CERTIFICATE OF APPROPRIATENESS PLACARD

- Changes to previously approved COA 074-16-CA.

Davie Street Presbyterian Church
COA 074-16-CA

Minor Works Application Description

NEW WORK - SOUTH ELEVATION 1/16"

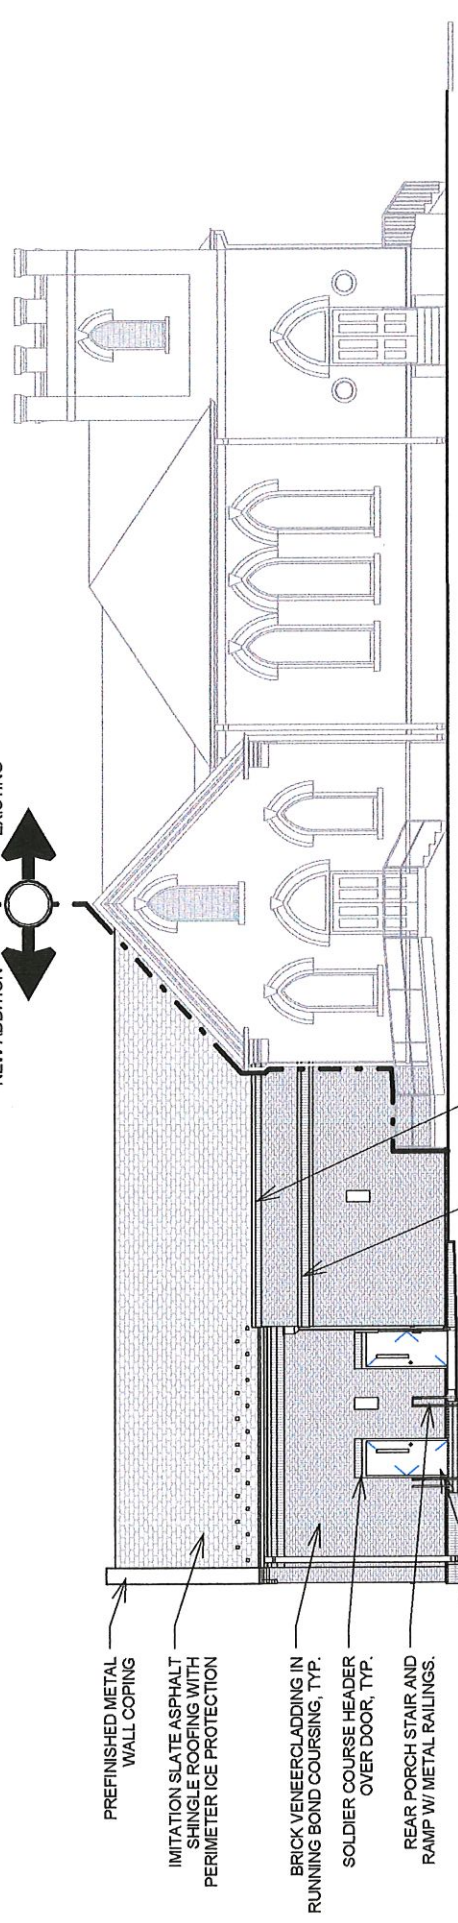
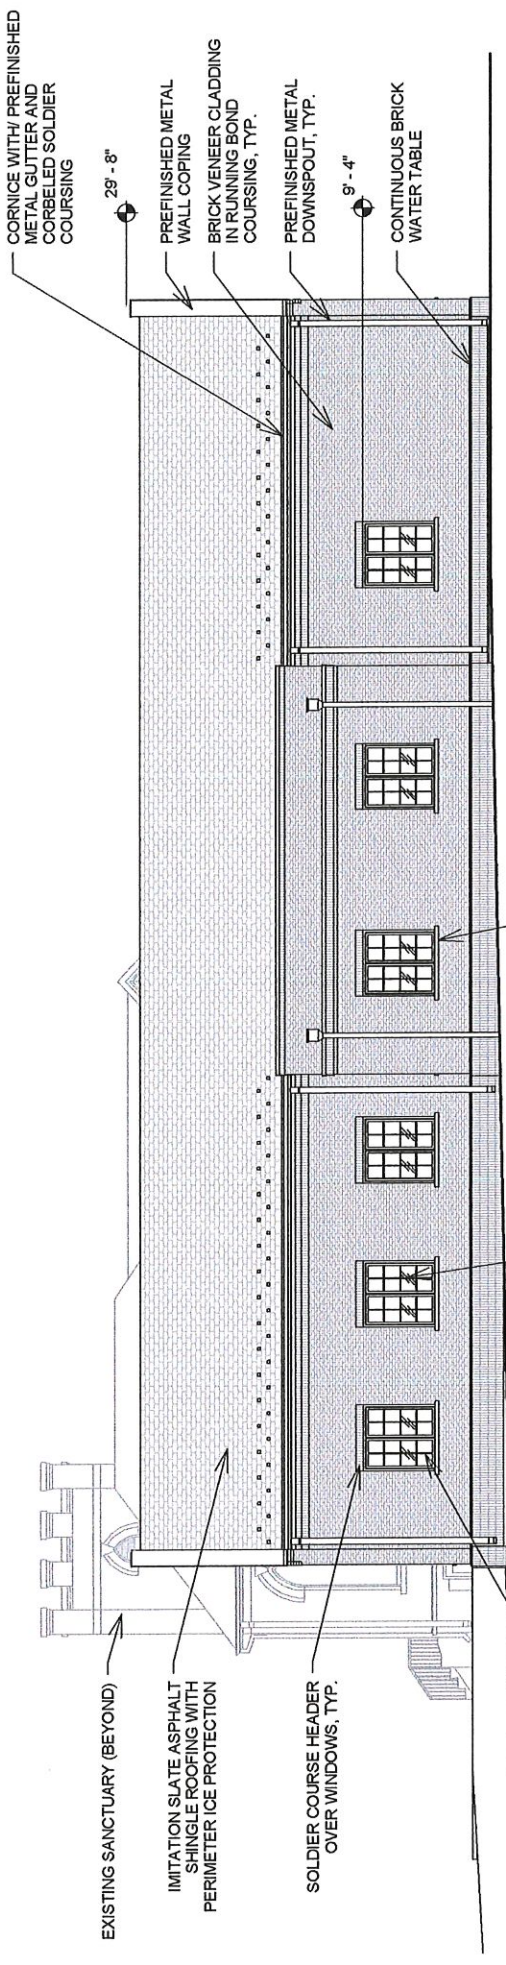
1. South Elevation: Remove the exit door and associated exterior ADA exit ramp and any associated rails
2. East and North Elevations: Remove the covered entry at the existing building. Door to remain.
3. East and North Elevations: Remove the extended shed roof porch covering the doors to the kitchen and fellowship hall. Doors and concrete patio to remain.
4. Steep sloped roof at fellowship hall: Utilize a GAF Slateline architectural asphalt shingle roof in lieu of a synthetic slate roof product.
